Groundwater Transfer Review Summary Form

Transfer/PA # T- 14899

Application: T-14899

Applicant Name: Lewis Land LLC c/o John Lewis

Map

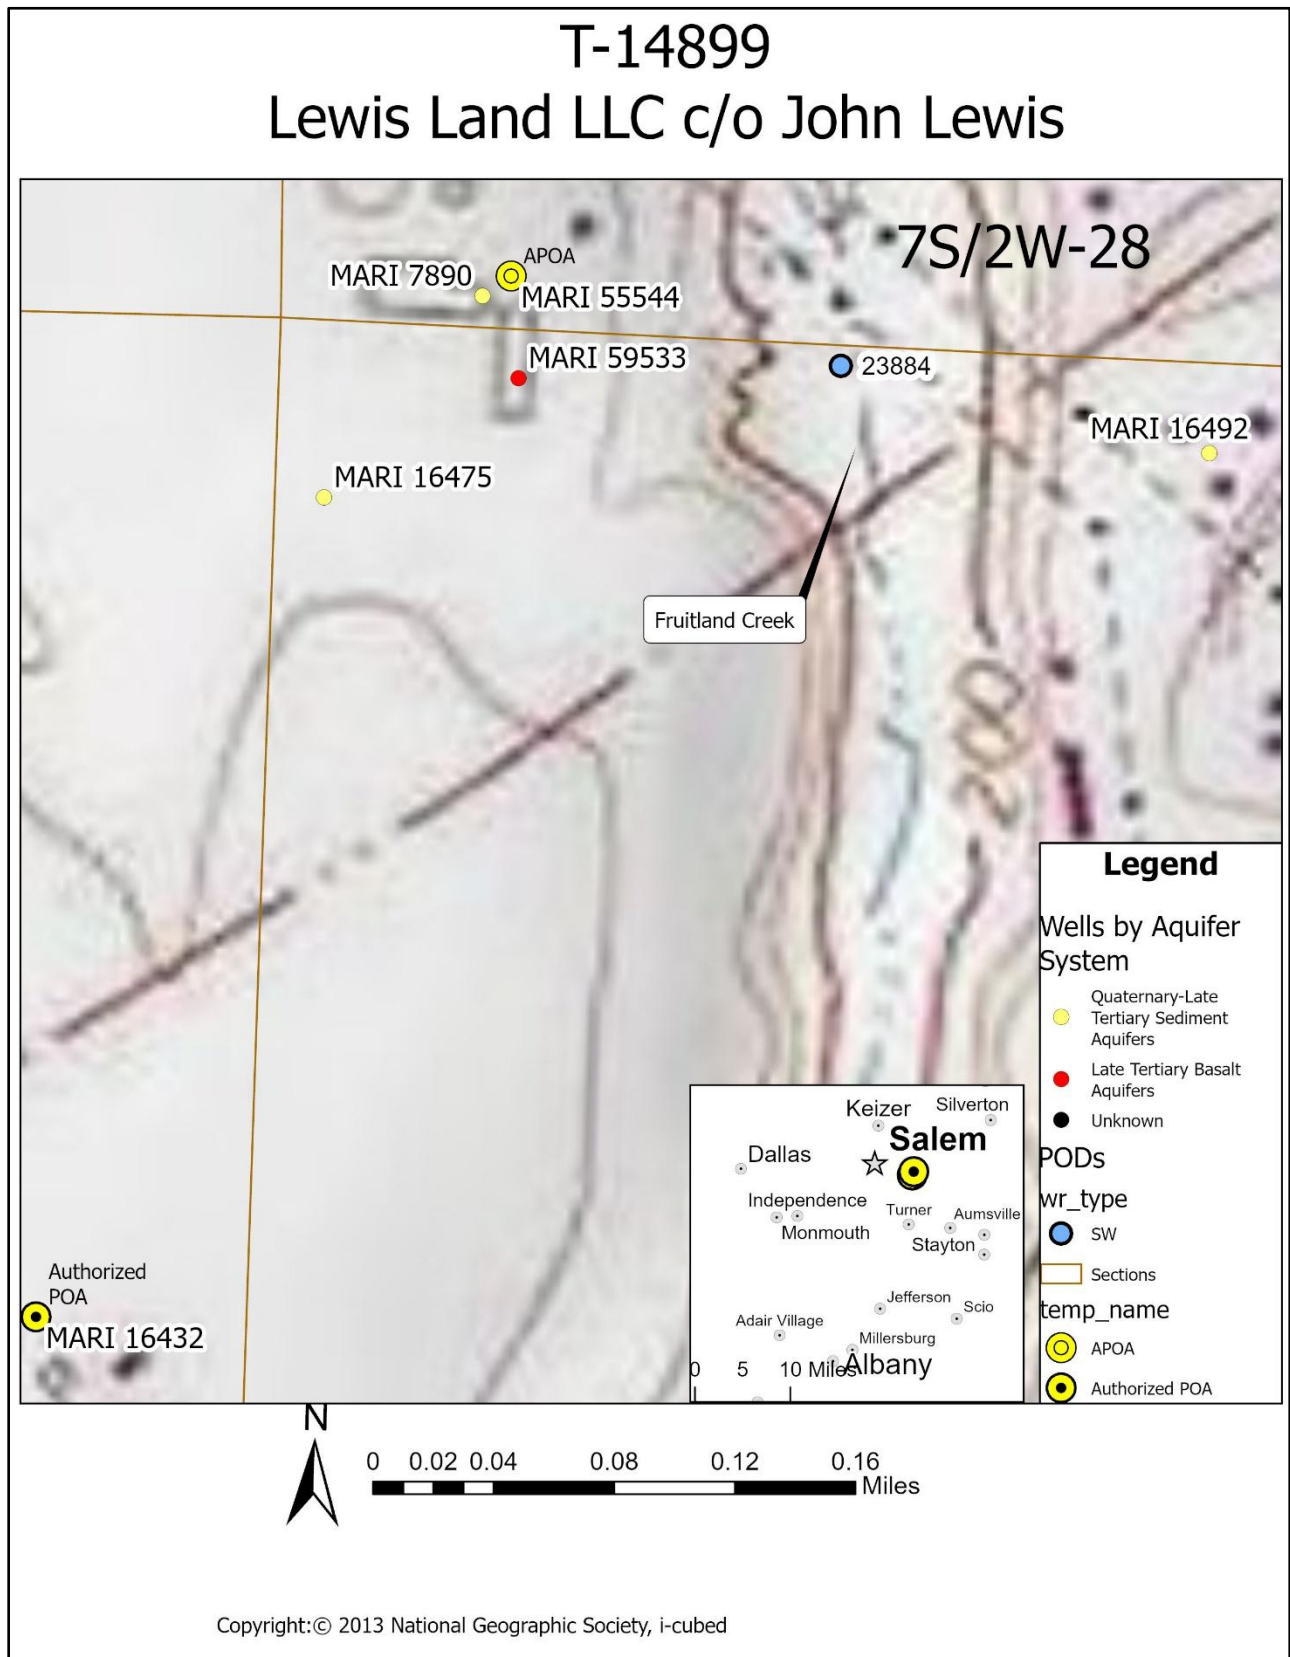
1. Basic description of the changes proposed in this transfer: Applicant proposes to add APOA Well 5 (MARI 55544) to Claim GR-3981. Claim GR-3981 authorizes MARI 16432 irrigation of 28.8 ac at a maximum rate of 0.223 cfs (100 gpm) and a maximum annual volume of 30 AF/year. Well 5 (MARI 55544) is also authorized under Permit G-18909. This review evaluates for the total rate shown in the table below.

5. a) Will this proposed change, at its maximum allowed rate of use, likely result in an increase in interference with **another ground water right**?
☒ Yes ☐ No Comments: Well 5 (MARI 55544) is closer to MARI 16492 a POA on Certificate 55206. The closer proximity to MARI 16492 will likely result in an increase in interference with Certificate 55206.

6. a) Will this proposed change, at its maximum allowed rate of use, likely result in an increase in interference with **another surface water source**?
☒ Yes ☐ No Comments: Well 5 (MARI 55544) is closer to Fruitland Creek. Although this stream is not perennial, there is a surface water POD under Certificate 23884 located 600 ft southeast of Well 5 (MARI 55544). The closer proximity to Fruitland Creek will likely result in an increase in interference with the surface water.

Theis Drawdown and Injury Analysis

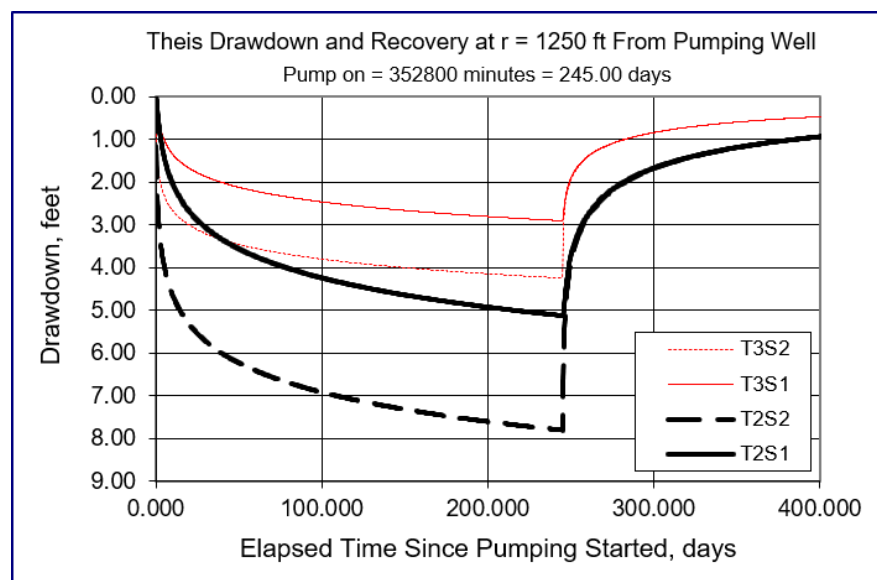
- b) If yes, would this proposed change, at its maximum allowed rate of use, likely result in another groundwater right not receiving the water to which it is legally entitled?
☐ Yes ☒ No If yes, explain: The proposed change was analyzed using the Theis (1935) solution for drawdown in a confined aquifer (see attached Theis Well Interference Analysis). Hydraulic parameters used for the analysis were derived from regional data and studies (Pumping Test Reports; Conlon et al., 2003, 2005; Iverson, 2002; McFarland and Morgan, 1996; Woodward et al., 1998). Results of the analysis indicate that pumping the proposed To-POA at the rate of 0.34 cfs is unlikely to result in injury at the location of MARI 16492.

The full rate of 0.593 cfs (266 gpm) could not be used for the entire 245-day irrigation season without exceeding the 105 AF annual volume. The averaged rate of 0.216072 cfs (97 gpm) could be used for the entire 245-day irrigation season to achieve an even distribution of the 105 AF annual volume. Scenarios T1S1 and T1S2 are not feasible as they result in de-watering of the pumping well within 4 hours, and are not shown below.

SWL	42 ft bls	MARI 16492
Aquifer Bottom	191 ft bls	Woodward et al., 1998
Available Water Column	149 ft	Aquifer bottom-SWL
Pump Height Above Bottom	5 ft	Estimate
NPSHa	5 ft	Estimate
Drawdown	10 ft	MARI 16492
Minimum Water Column	20 ft	Estimated Drawdown + NPSHa + Pump Height
Injury	129 ft	Available Water Column-Minimum Water Column
